APPENDIX C

LINSIG MODELLING AUDIT PROCESS

PROJECT
HOLLOWAY PRISON

DRAWING TITLE
PROPOSED SOUTHERN SITE ACCESS JUNCTION

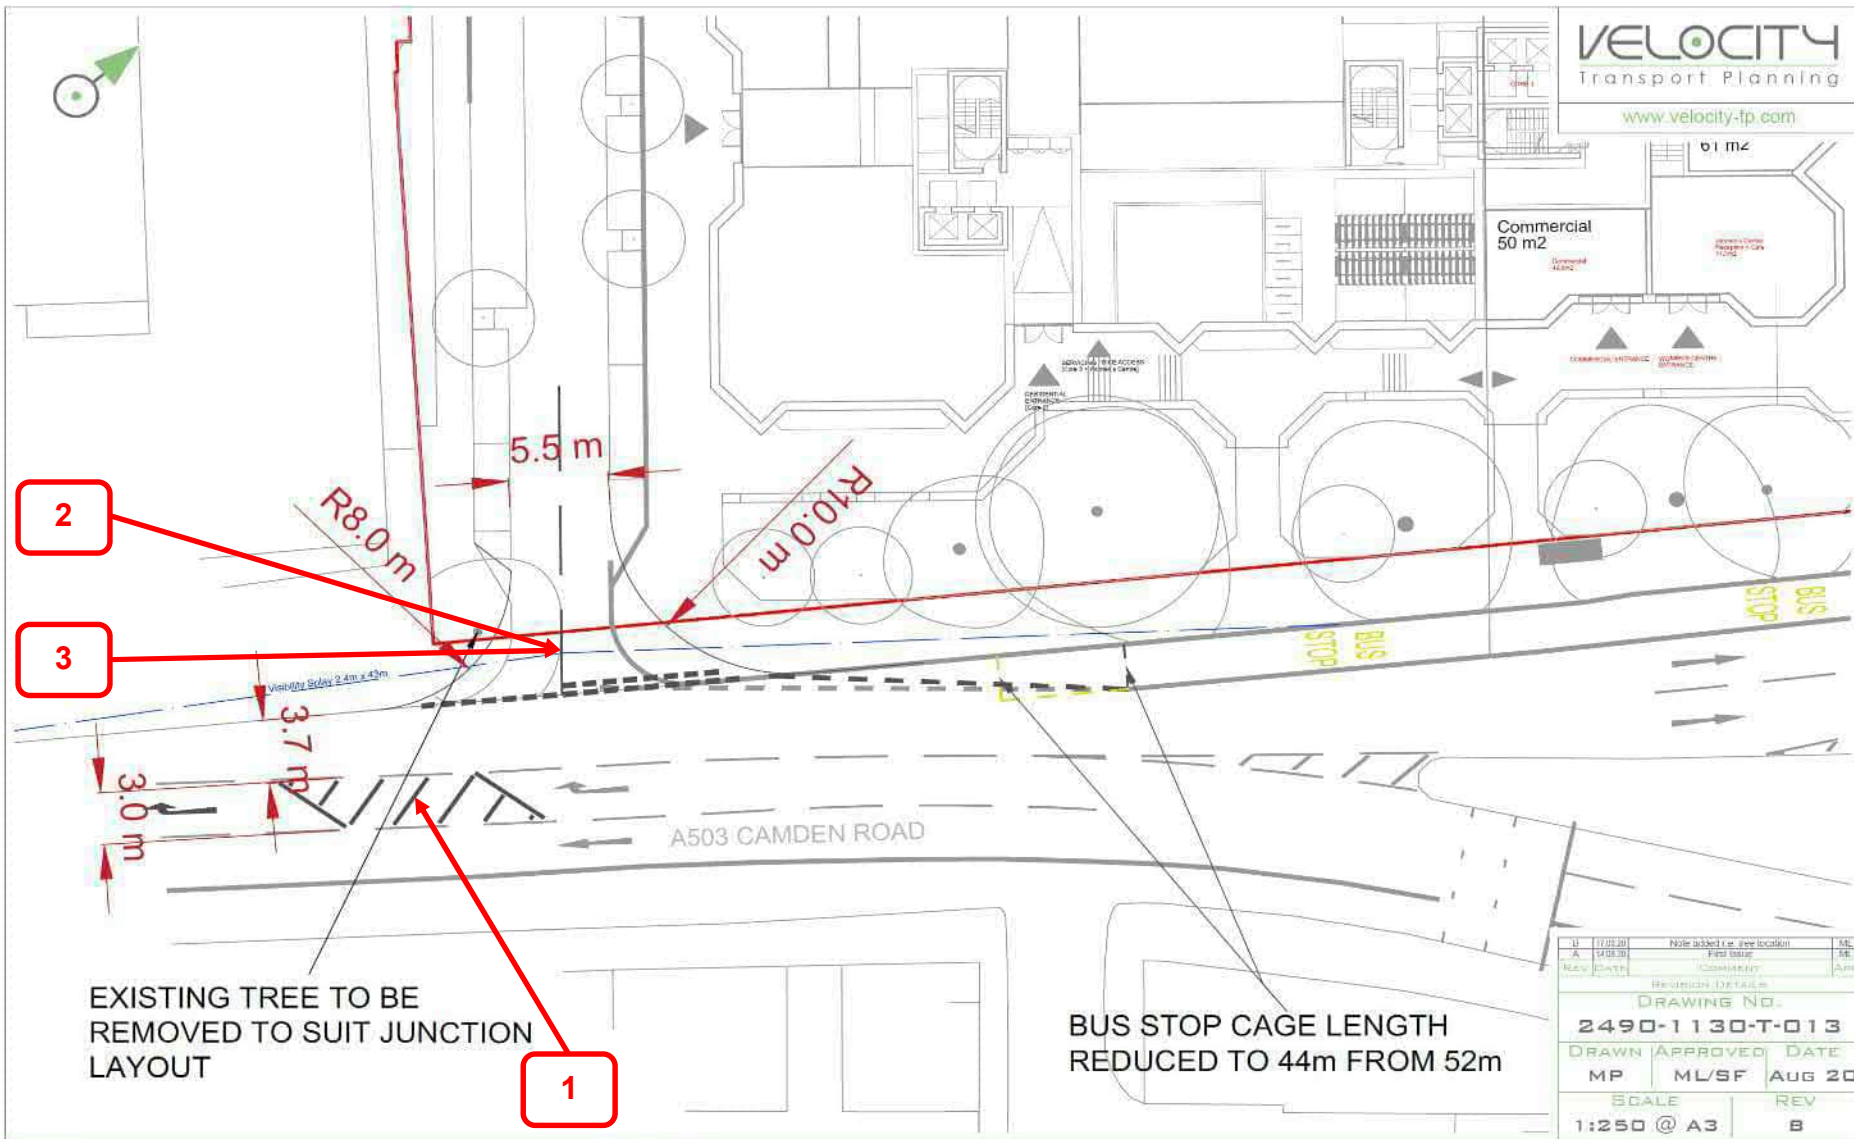
The traffic separation island should not be designed in a manner which could attract pedestrian movements across the Camden Road carriageway, particularly as a signal-controlled crossing facility is situated to the south, adjacent to the Dalmeny Avenue junction. The recommended traffic separation island will assist drivers to recognise the difference between the correct right turn facility to be utilised, commensurate with their respective destinations.

It is Recommended that the junction geometry and the initial length of the southern site access road should be modified, in order to remove and mitigate the potential collision scenarios described above.

The site visit has established the presence of trees and mature vegetation on both sides of the proposed location of the southern site access junction, which will impact upon the proposed visibility splays of 2.4 x 43 metres indicated on the scheme drawing. Concern arises that the impact upon the proposed visibility splays could result in a potential increased risk of side impact collisions occurring between

Design Organisation Response	Rejected
<p>The proposed geometry of the junction is suitable to accommodate vehicles expected to access and egress the development site, including; refuse vehicle and 10m rigid vehicle, however, movements by large vehicles will result in overrunning the centre lane at the minor arm.</p> <p>The proposed development is car free and will generate very low number of vehicle trips throughout the day. It was estimated that the development will generate a maximum of 13 vehicle trips (including two large vehicles only) to or from the development site during the peak hour at the southern access point. This equates to a vehicle movement every three minutes. This volume of movements, and a low proportion of heavy vehicles, is unlikely to results in conflicts at the junction.</p> <p>Geometric changes to the design of the junction, necessary to accommodate opposing movements by large vehicle and a car, would have resulted in an over-design geometry for the predicted use of the junction, (i.e. increased width of the pedestrian crossing and larger kerb radius). These geometric changes would have resulted in vehicles negotiating through the junction with greater speed that would compromise pedestrian safety.</p> <p>As such, the proposed design is considered suitable for the predicted vehicle movements expected to access and egress the development site through the southern junction.</p>

Design Organisation Response	Accepted
<p>It is proposed that the existing trees fronting the development will be removed as part of proposal. This includes the tree and vegetation immediately to the south of the proposed site access that would have otherwise affected the visibility splay to the right.</p> <p>The visibility to the left is achieved and the landscaping proposed to the front of the site will further improve visibility at this location.</p>	
Client Organisation Comments

DRAWING TITLE
REDESIGNED NORTHERN SITE ACCESS JUNCTION

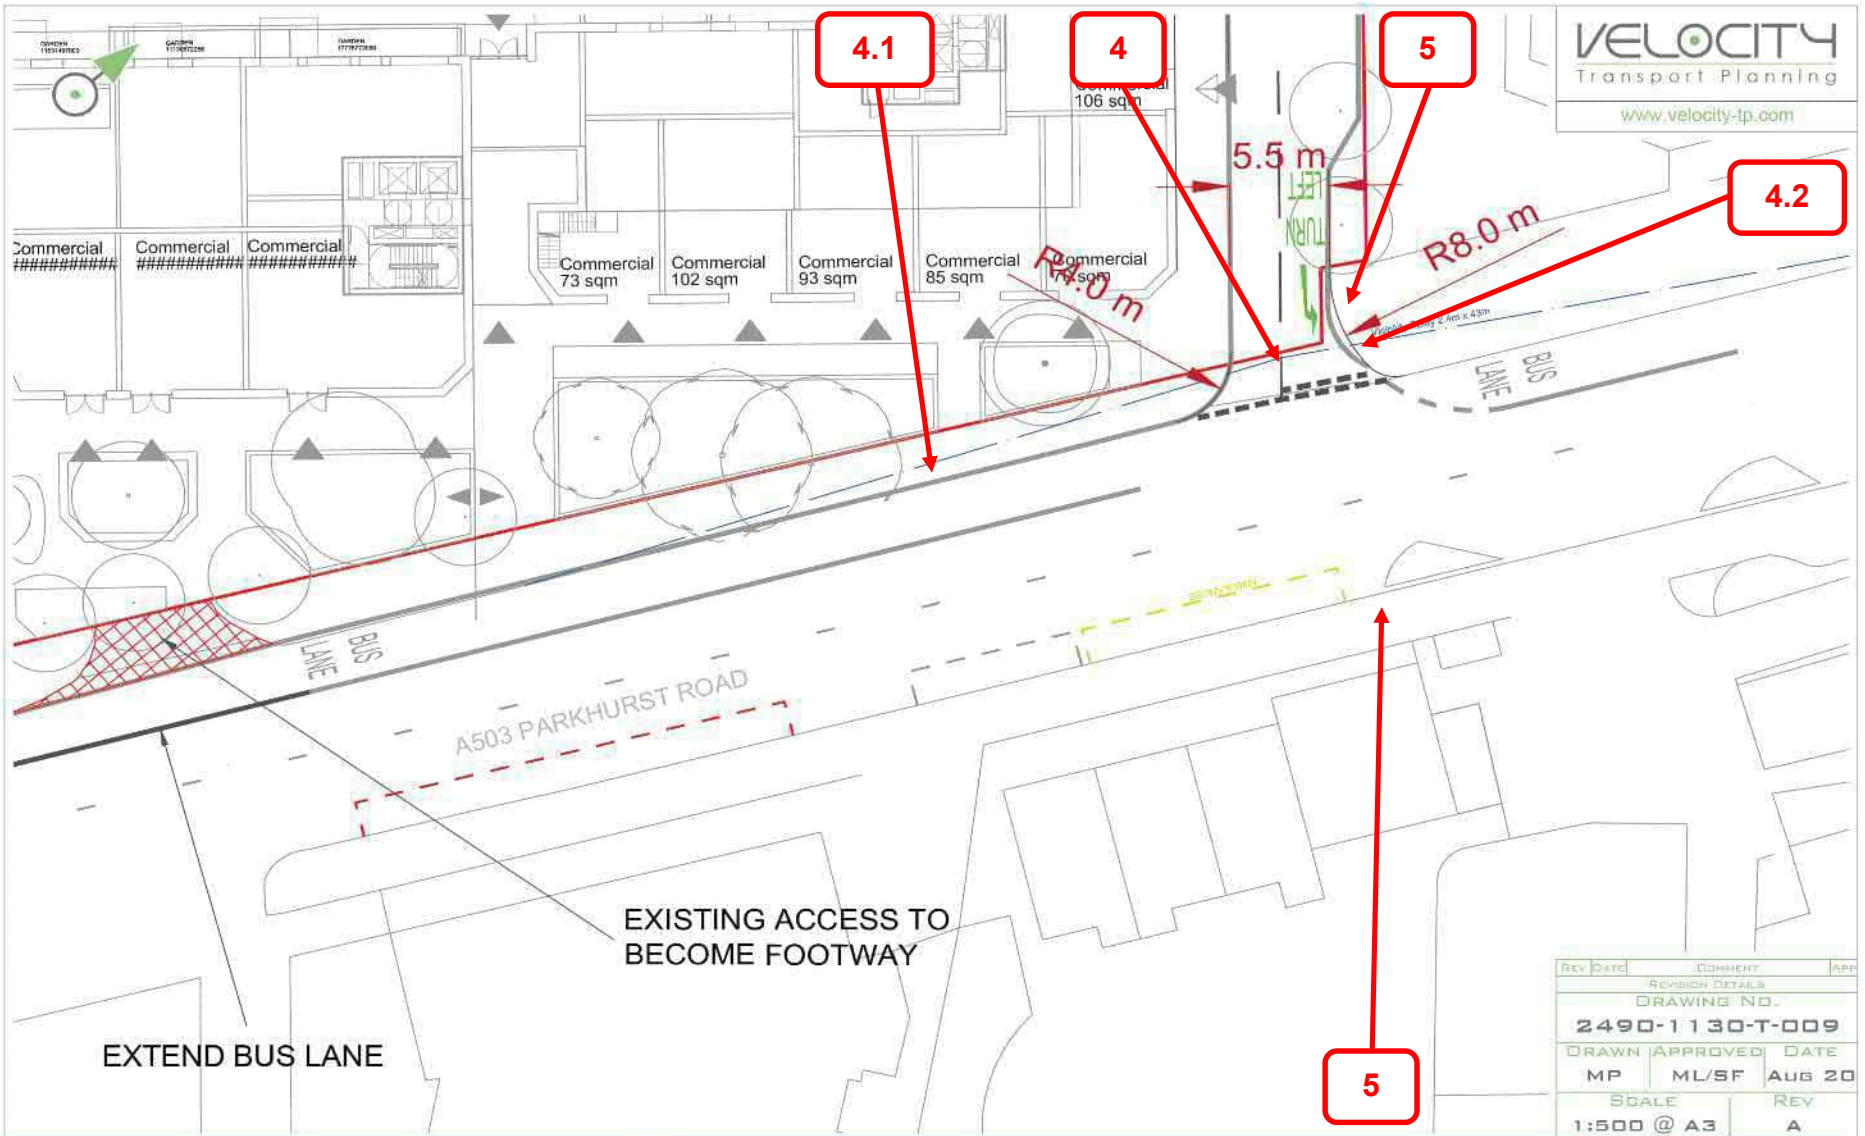
It is Recommended that the junction geometry and the initial length of the northern site access road should be modified, in order to remove and mitigate the potential collision scenarios described above.

Design Organisation Response	Rejected
<p>The proposed geometry of the junction is suitable to accommodate vehicles expected to access and egress the development site, including; refuse vehicle and 10m rigid vehicle, however, movements by large vehicles will result in overrunning the centre lane at the minor arm.</p> <p>The proposed development is car free and will generate very low number of vehicle trips throughout the day. It was estimated that the development will generate a maximum of 13 vehicle trips (including two large vehicles only) to or from the development site during the peak hour at the southern access point. This equates to a vehicle movement every three minutes. This volume of movements, and a low proportion of heavy vehicles, is unlikely to result in conflicts at the junction.</p> <p>Geometric changes to the design of the junction, necessary to accommodate opposing movements by large vehicle and a car, would have resulted in an over-design geometry for the predicted use of the junction, (i.e. increased width of the pedestrian crossing and larger kerb radius). These geometric changes would have resulted in vehicles negotiating through the junction with greater speed that would compromise pedestrian safety.</p> <p>As such, the proposed design is considered suitable for the predicted vehicle movements expected to access and egress the development site through the southern junction.</p>

Design Organisation Response	Accepted
A turn left regulatory traffic sign to Diagram 606 will be included as part of the design and the recommended locations will be considered at the detail design stage (i.e. sited directly opposite the northern site access junction within the Parkhurst Road eastern footway, or on the corner of the northern site access junction prior to the Parkhurst Road carriageway).	
Client Organisation Comments
